United States Department of the Interior

BUREAU OF LAND MANAGEMENT

On June 9, 2009, the Bureau of Land Management (BLM) received and reviewed Solar Millennium's third update to the Plan of Development (POD) for the proposed Ridgecrest Solar Power Plant (Project), filed under BLM Serial Number CACA-049016. The BLM also reviewed Solar Millennium's Application for Certification (AFC) filed with the California Energy Commission (CEC) September 1, 2009.

Solar Plan of Development Check-List		
POD Page #	AFC Page #	Description	Adequate Info.	Deficient Info.	Notes
		Introduction			
Pg 6	1.1	Type of Facility	✓		
Pg 6	2.5.7	Planned	✓		
Pg 6	2.0/ 2.1	Generation Output	✓		
Pg 6	2.5.7	Project schedule	✓		
Pg 59	5.2/5.3-3 5.5-3/5.7-5 5.12-3 5.13-3 5.16-3 7.17-3 5.18-5	Permitting timelines	✓		
Pg 61	2.5.7.1	Construction/Operation Timelines including phases	✓

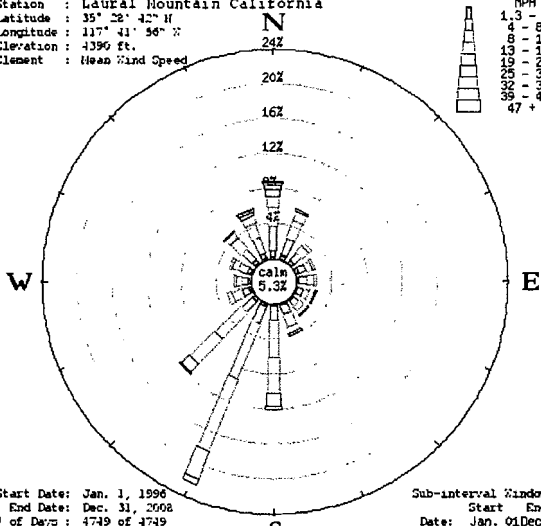
n/a	Backup natural gas generation requirements	✓		
Pg 9	Fig 5.17-6	Pipeline routing considerations and		✓	<ul style="list-style-type: none"> Water pipeline may affect 3.3 miles of BLM. SM

Solar Plan of Development Check-List		
POD Page #	AFC Page #	Description	Adequate Info.	Deficient Info.	Notes
	Fig. 5.17-6b	construction standards			<p>Engineers verbally claim BLM lands will not be affected. BLM wants confirmation with drawings and detailed plan of construction. Include ownership on the maps.</p> <ul style="list-style-type: none"> • Will the pipeline be used for other entities? • What will be the resource impacts, i.e., desert tortoise and MGS habitat, cultural, etc., during waterline installation? • Provide detailed drawings of the pipeline location. Any proposed disturbance to public land will requires pre-project DT surveys. • Were the proposed project supply wells before IWVWD pipeline? If so remove from maps. If not, explain what they are for?
Pg 47		Metering stations		✓	<ul style="list-style-type: none"> • Discuss with the BLM regarding metering stations for dust, water, etc. (Refer to Draft BMP)
